APPLICATION FOR PERMIT TO DRILL, DEEPEN, OR PLUG BACK

2. NAME OF OPERATOR Northwest Pipeline Corporation		7. UNIT AGREEMENT NAME San Juan 30-5 Unit
3. ADDRESS OF OPERATOR P.O. Box 90, Farmington, New Mexico 87401		8. FARM OR LEASE NAME San Juan 30-5 Unit

SUNDRY NOTICES AND REPORTS ON WELLS

REQUEST FOR APPROVAL TO: SUBSEQUENT REPORT OF:
TEST WATER SHUT-OFF ☐ ☐
FRACTURE TREAT ☐ ☐
SHOOT OR ACIDIZE ☐ ☐
REPAIR WELL ☐ ☐
PULL OR ALTER CASING ☐ ☐
MULTIPLE COMPLETE ☐ ☐
CHANGE ZONES ☐ ☐
ABANDON* ☐ ☐
(other) Change Locations

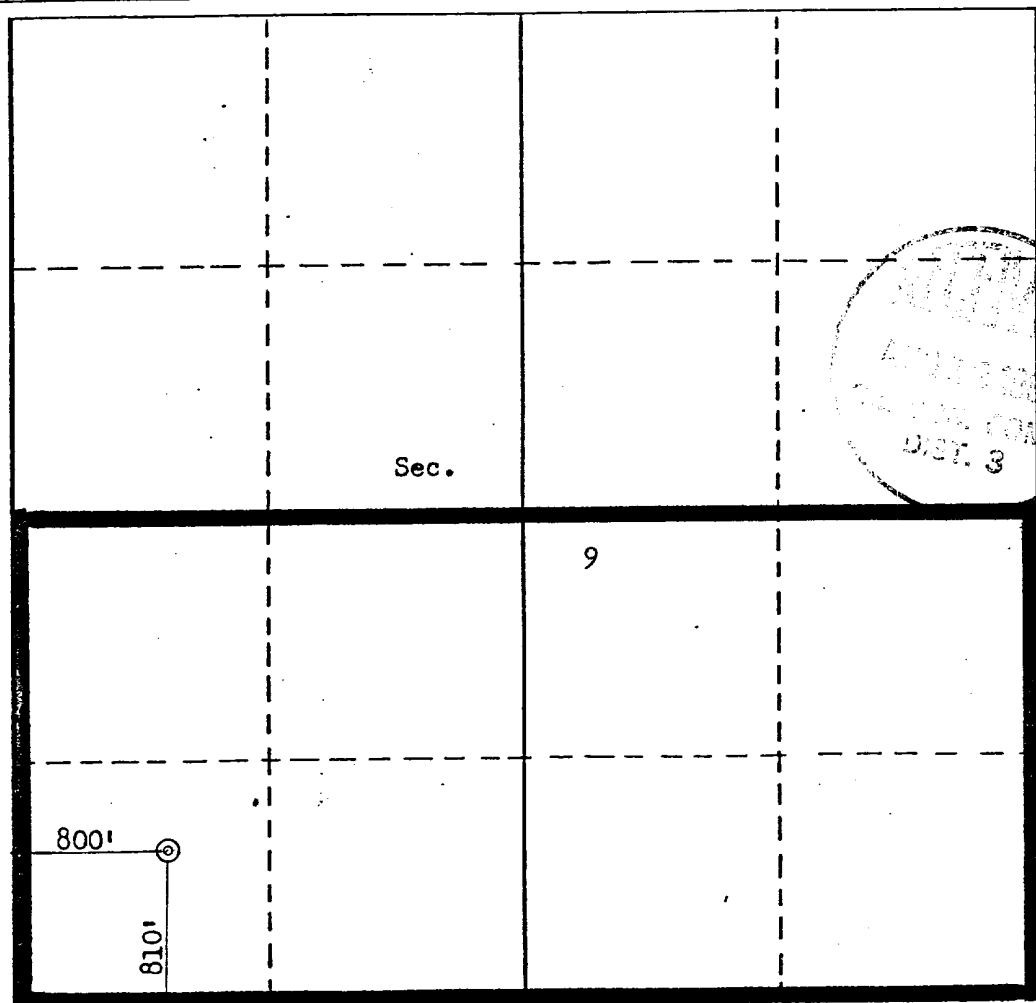
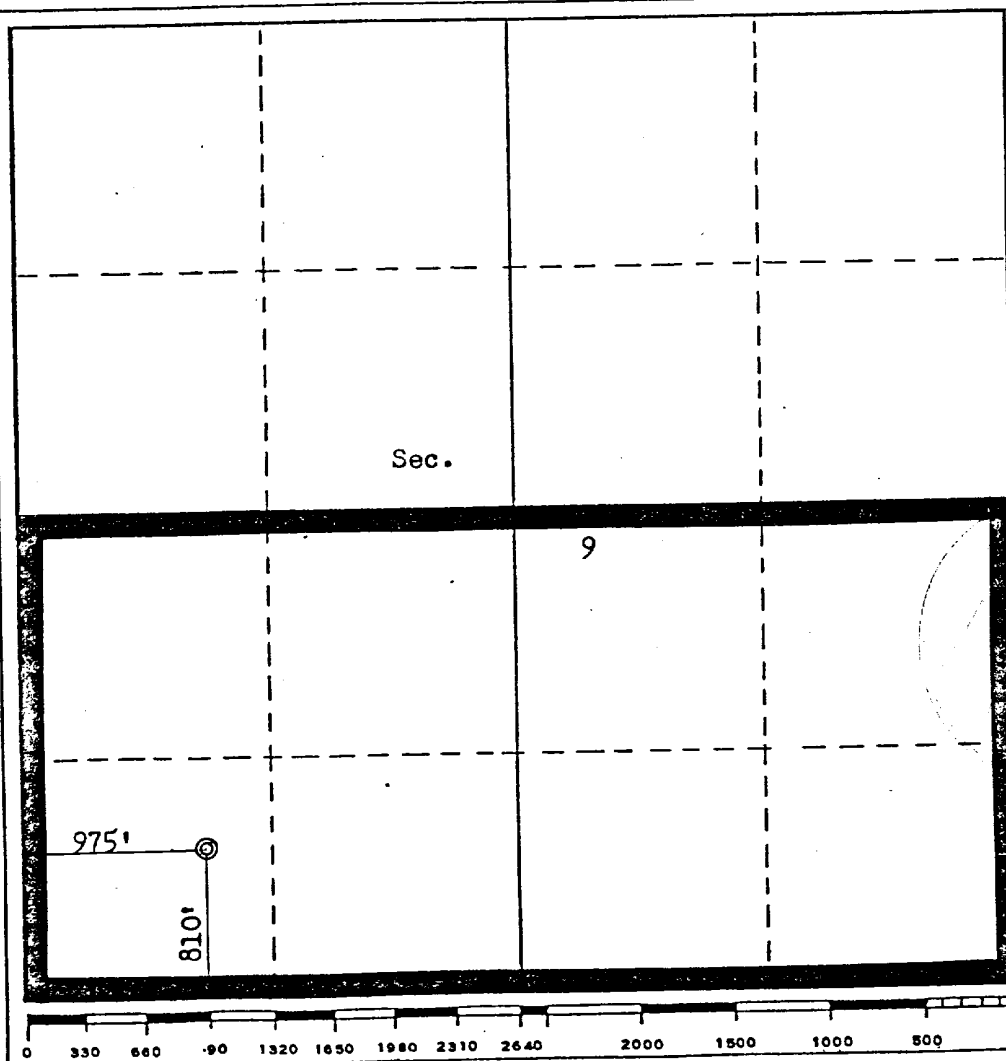
This well location has been changed because of pipeline under location.

Old Location: 810' FSL & 975' FWL

New Location: 810' FSL & 800' FWL
